South Texas Project
Units 1 & 2
Docket Nos. STN 50-498, STN 50-499
STPNOC Second Six-Month Status Report in Response to March 12, 2012 Commission Order
Modifying Licenses with Regard to Requirements for Mitigation Strategies
For Beyond-Design-Basis External Events (Order Number EA-12-049)

**STP Nuclear Operating Company (STPNOC) Second Six-Month
Status Report for the Implementation of Order EA-12-049, Order
Modifying Licenses with Regard to Requirements for Mitigation
Strategies for Beyond-Design-Basis External Events**

Conceptual Drawing - FLEX Electrical Distribution System

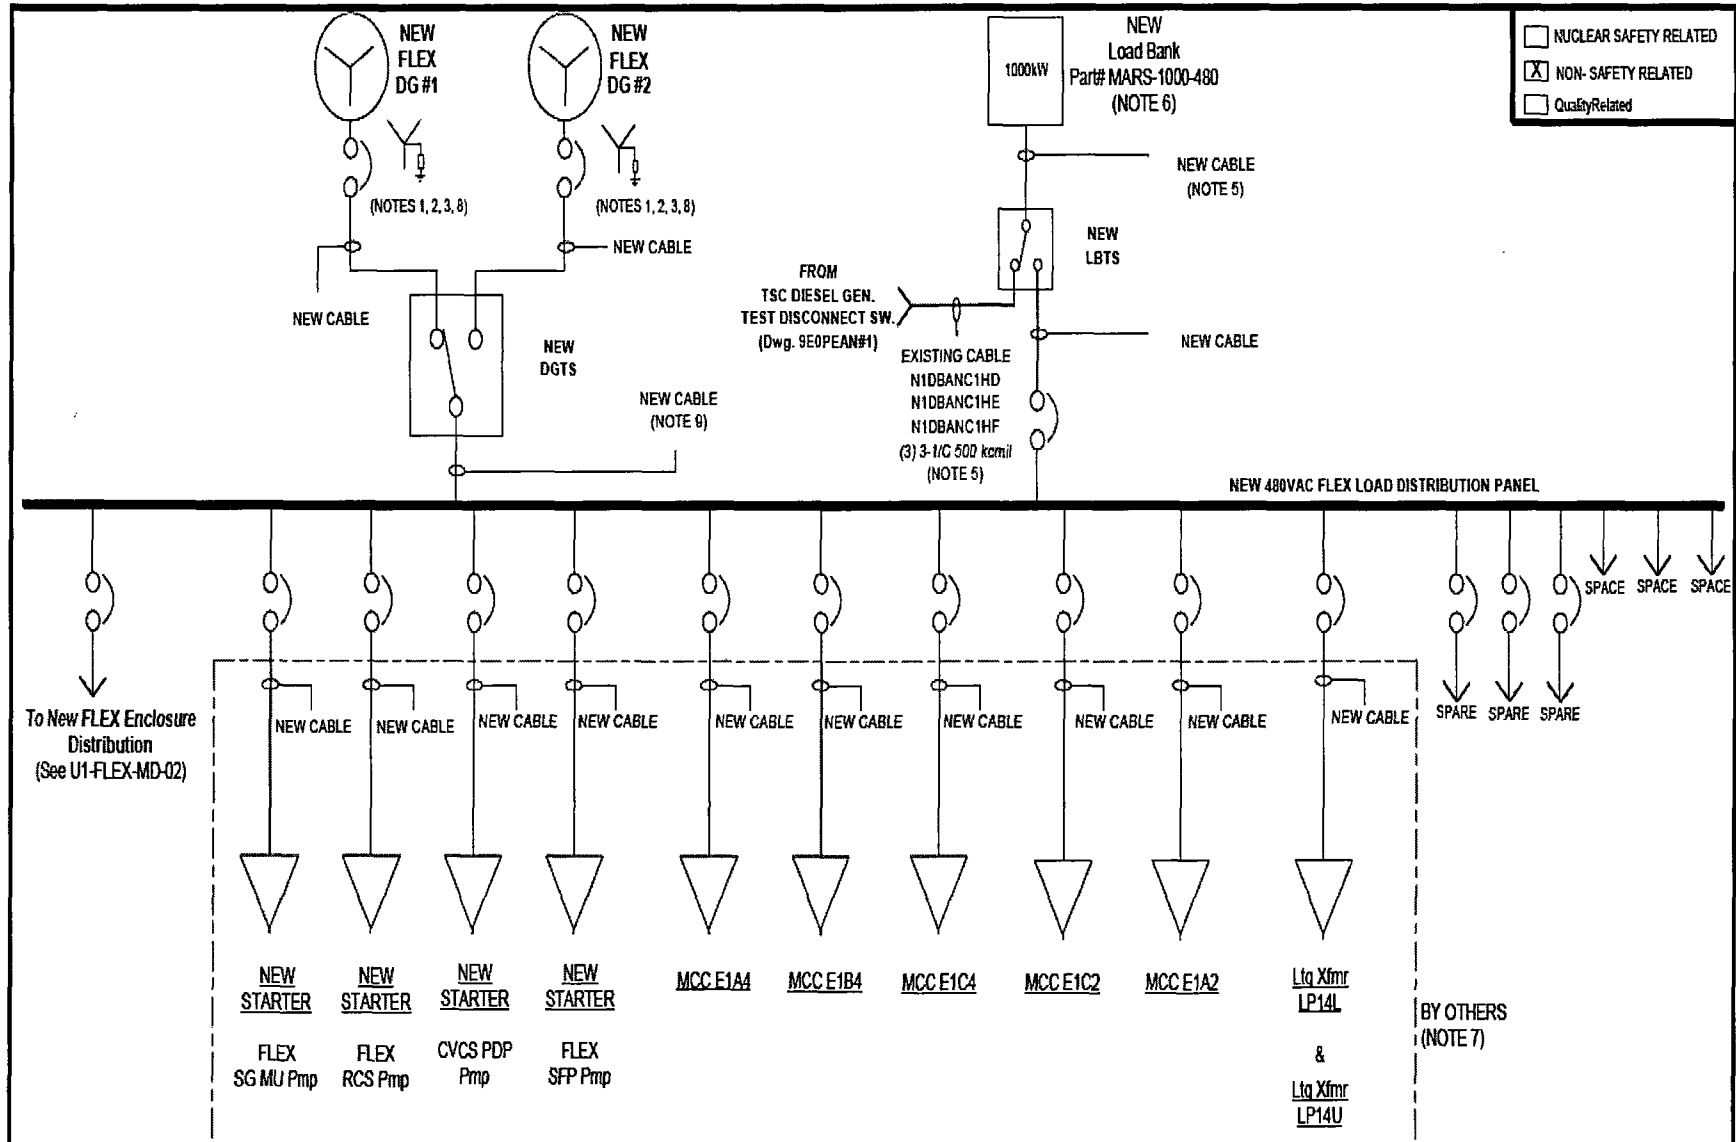
- B. The capacity of the diesel generators has been increased to 1000 kW at 480V to accommodate running more equipment.
- C. For Modes 1-4 Core Cooling, STP's strategy has been updated to:

The two pre-staged 480VAC 1000kW DGs are capable of providing the protection called for in the Order. New cables will be run from a new FLEX distribution panel located near the new FLEX DGs either through existing electrical system pathways (cable trays) or through conduits that meet the requirements associated with initial plant construction standards.

Conceptual Drawing – Spent Fuel Pool Makeup

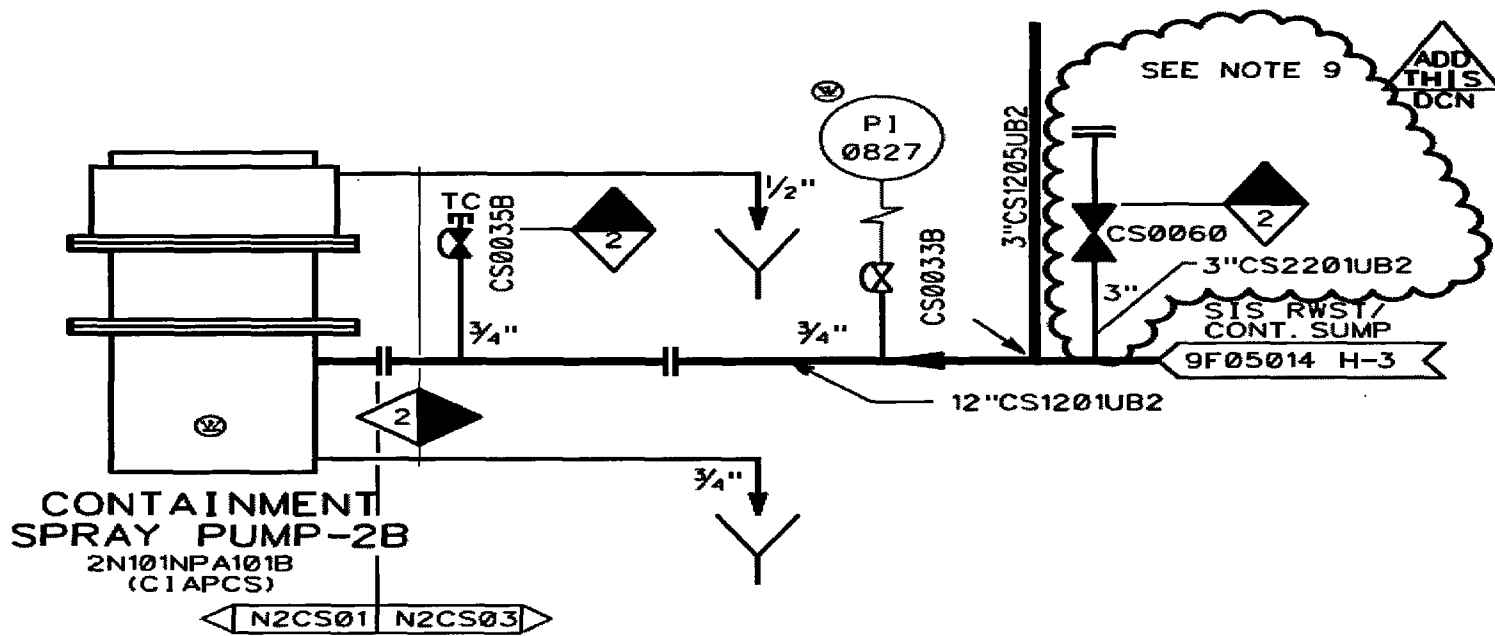
- H. The new FLEX SFP makeup pump has been updated to a rating of 250 gpm at 150 psig. This pump will be used both for makeup using hoses and for spray.

Conceptual Drawing – Reactor Coolant System Makeup FLEX Pumps

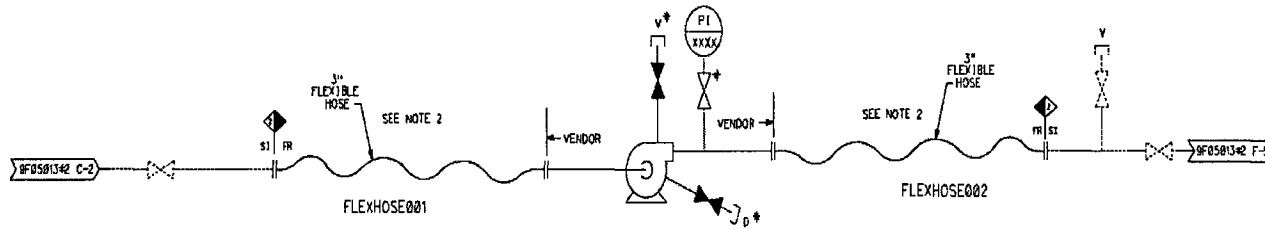
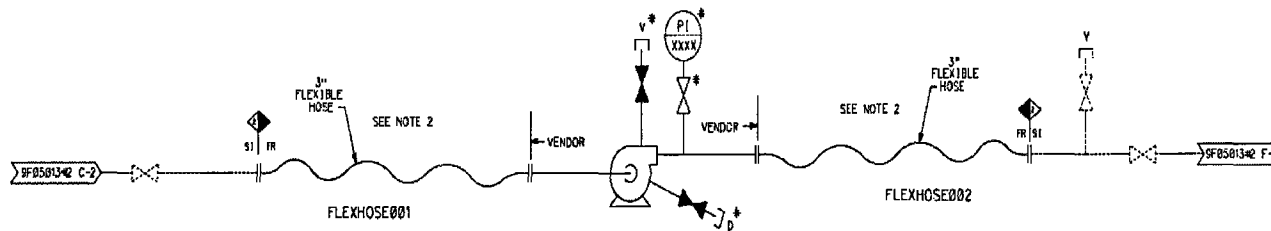
- D. The FLEX RCS Makeup pump was originally rated at 1500 psi but has been updated to a rating of 700 psi. STP can open the Reactor Head Vents as necessary during this event.

- F. The FLEX power diesel generator enclosures on top of the MAB will be made of steel vice concrete.
- G. For Modes 5 and 6 Core Cooling, a new FLEX pump rated at 170 gpm at 100 psig will be used as the primary strategy and a Boric Acid Transfer pump will be used as the alternate strategy.

Conceptual Drawing – Steam Generator Makeup (RCS Core Cooling)

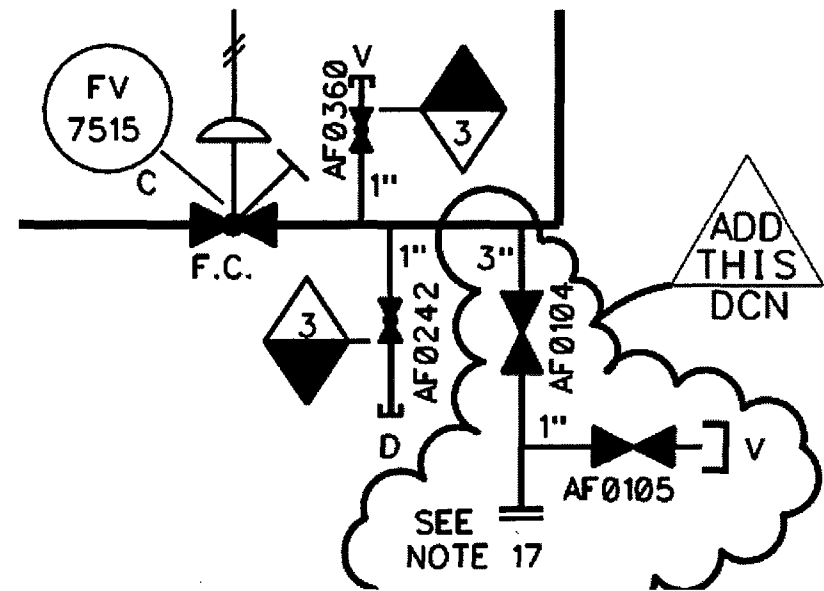
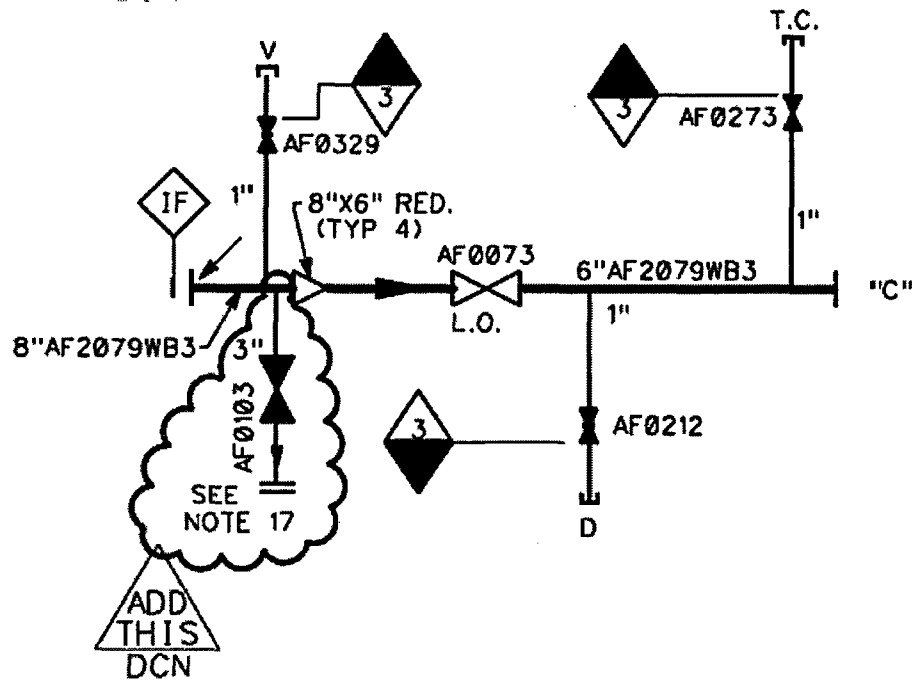
- a. Use the Turbine Driven Auxiliary Feedwater (TDAFW) pump in Phase 1.
 - b. Use the new 300 gpm at 500 psig FLEX SG fill pump as the primary strategy to back up the TDAFW pump during Phase 2.

- c. Use the trailer mounted portable diesel driven pump feeding the Main Feedwater lines as the alternate strategy. This strategy cannot be used for about 72 hours following a Main Reservoir embankment breach flood but can be used immediately for all other external events.
